SERVICE BULLETIN No 10-23

PRODUCTION CHANGE

SUBJECT: CHROMIUM PLATED INTAKE & EXHAUST VALVES
VEHICLES: 3.2 MONDIAL AND 328

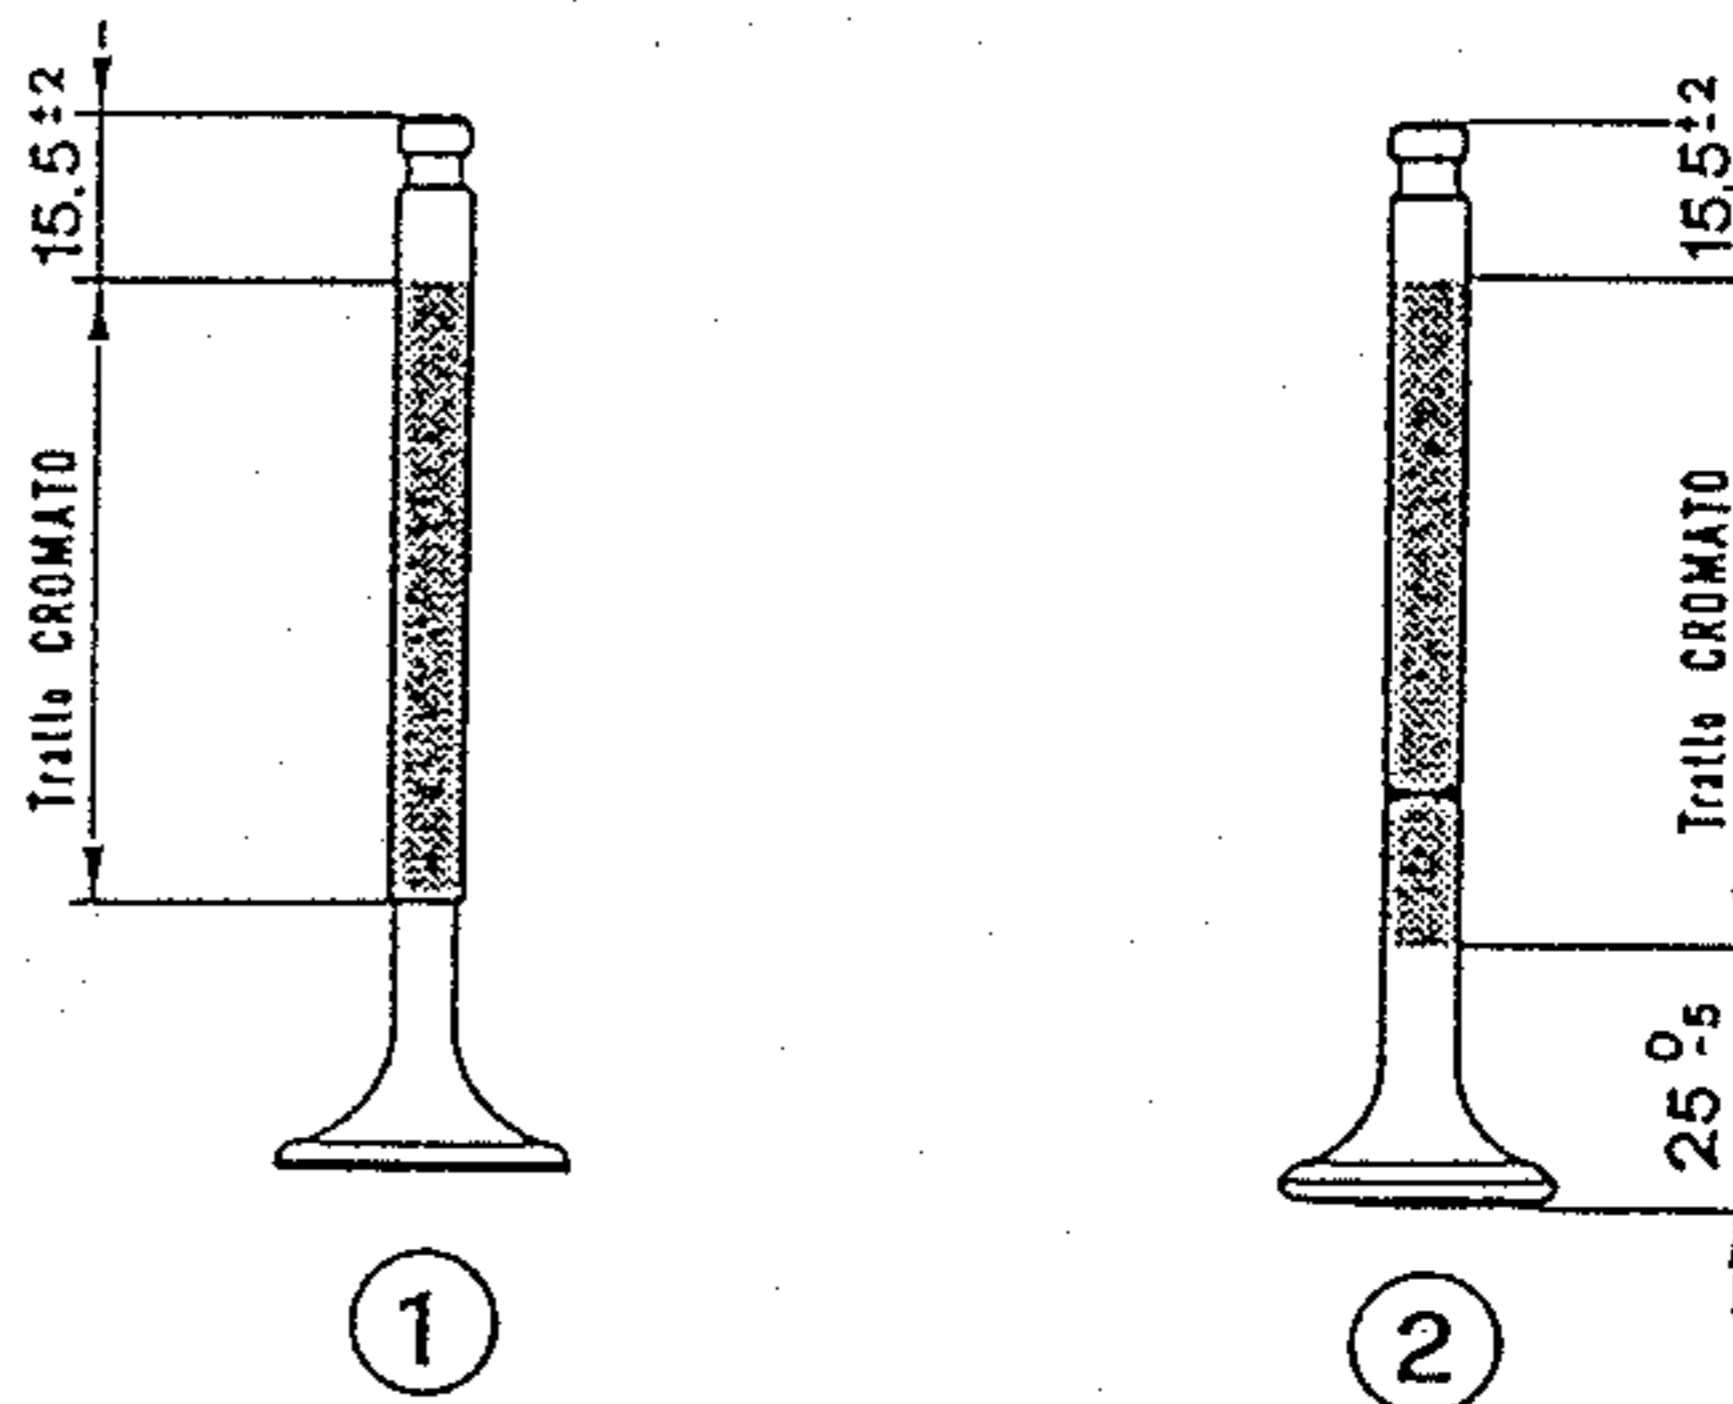
New valves are installed with chromium-plated stem.

Better quality.

REPLACED PARTS			NEW PARTS		
ref. fig.	Part Number	Description	ref. fig.	Part Number	Description
1	117363	Intake valve	1	131198	Intake valve
2	117364	Exhaust valve	2	131199	Exhaust valve

The new valves are interchangeable with previous ones.
